PGT/PG&E AND ALTAMONT
NATURAL GAS PIPELINE PROJECTS
FINAL
ENVIRONMENTAL IMPACT
STATEMENT

COMMENTS/RESPONSES

Federal Energy Regulatory Commission Washington, D.C.

MAY 1991

Figure 1 Vicinity Map John Day Variation

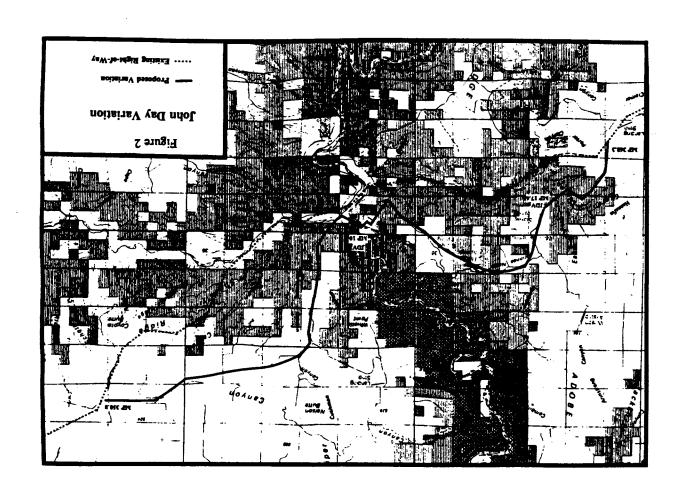
As shown in Figure 1, the John Day Variation is located in northern Oregon, in the vicinity of the John Day River Canyon. The Variation deviates from the existing PGT pipeline right-of-way for a total distance of 21.4 miles (see Figure 2). Initiating at M.P. 350.8 of the existing PGT right-of-way, the Variation travels 7.5 miles southwesterly across the Columbia Plateau. The proposed alignment then descends sharply into the John Day Canyon, crosses the John Day River at M.P. 10¹, and immediately ascends back onto the Columbia Plateau. The route proceeds southwesterly and drops down into Hannafin Canyon at approximately M.P. 17.6. The Variation returns to the existing PGT right-of-way about one mile north of Compressor Station No. 10 at M.P. 368.3.
